July 15, 1981

Subject: Calvert Cliffs Nuclear Power Plant  
Units Nos. 1 & 2; Dockets Nos. 50-317 & 50-318  
Auxiliary Feedwater System Modifications

Figure 1

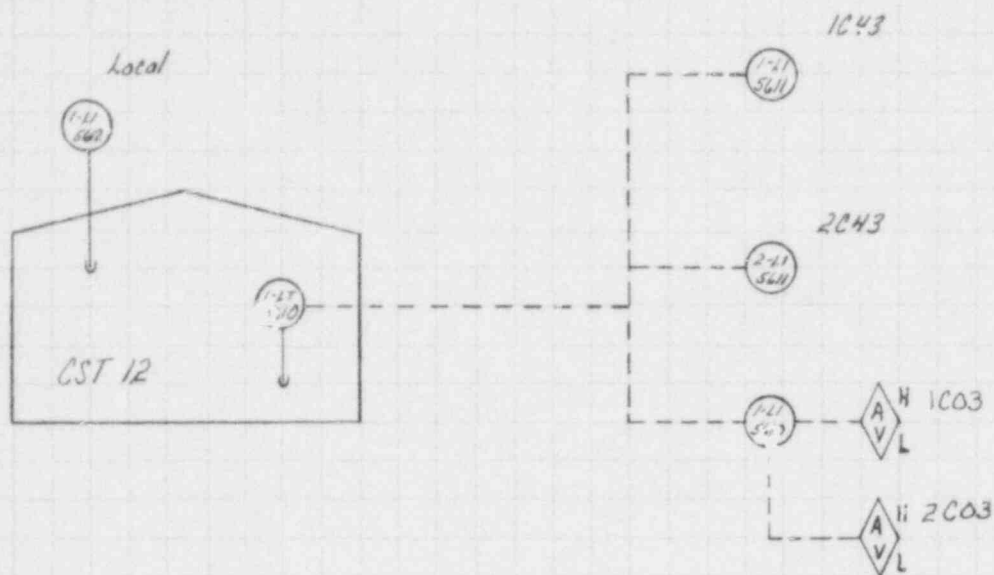
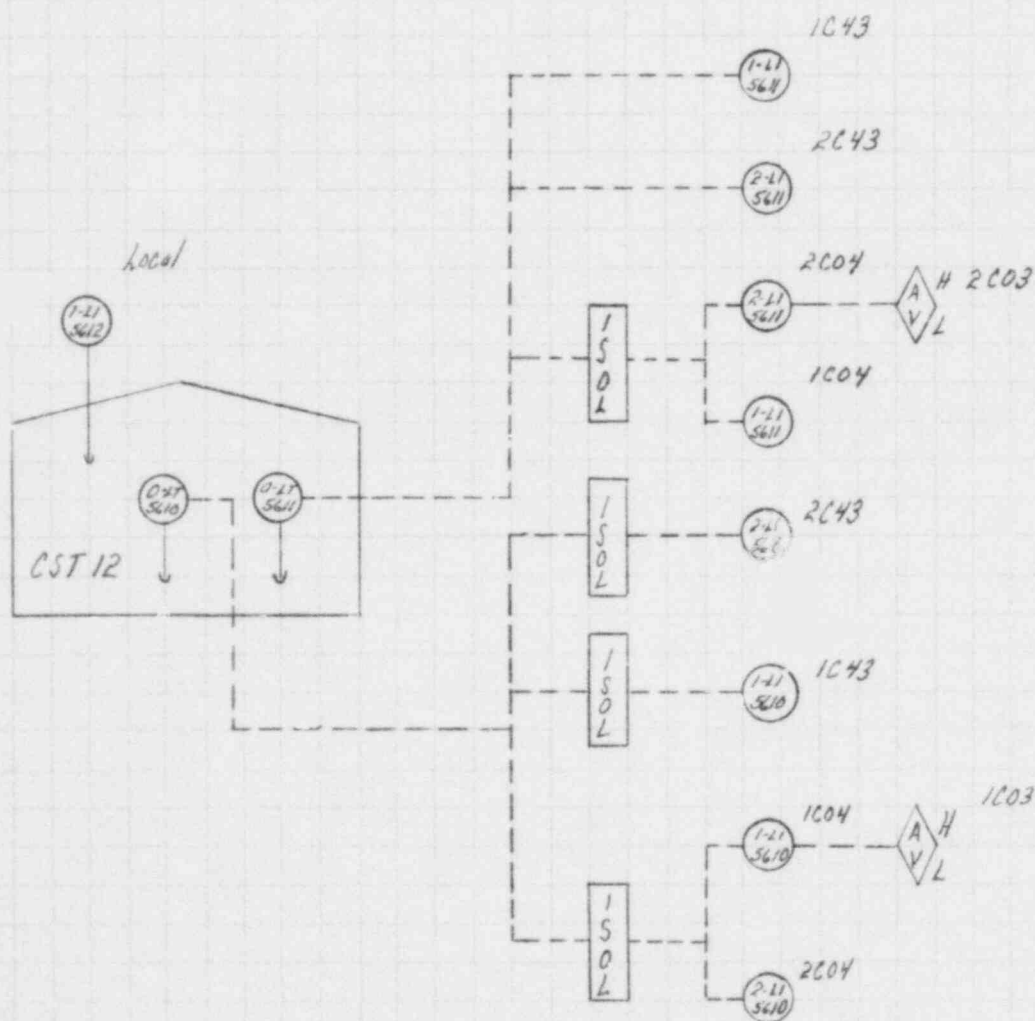
At present, as shown in Figure 1, Condensate Storage Tank (CST) No. 12 has a local level indicator and a level transmitter which provides level indication and alarm at the Auxiliary Shutdown Panels (ASPs) and in the Control Room. In conjunction with the Auxiliary Feedwater (AFW) modifications, as discussed in reference (b), we will be installing an additional level transmitter for CST No. 12 and providing redundant indication in the control room and at the ASPs, as shown in Figure 2.

The following design criteria will be met for the purchase and installation of the equipment.

1. The equipment will be supplied in accordance with the IEEE requirements for class 1E equipment; i.e., IEEE 323-74 for environmental qualification.
2. Complete isolation will be provided between redundant circuits.

3. ASP indication will be completely isolated from the control room.
4. The system will meet the seismic criteria of IEEE 344-75 with the exception of the cable routing to the level transmitter of the CST. This cable will be routed through the non-seismic turbine building and existing pipe tunnel outside to the condensate tank area.

5. The system will be single failure proof, with the exception of local indication.
6. There will be redundant indication in the control room and at the ASPs. In addition, the local level indicator is available. Dual alarm capacity is installed.

7. The cable routing will meet the physical separation criteria of IEEE-384.
8. Each indicator will be powered from a separate vital AC power source.
9. The level indicators will cover the full range of CST level. No recording of instrumentation readout information will be provided.
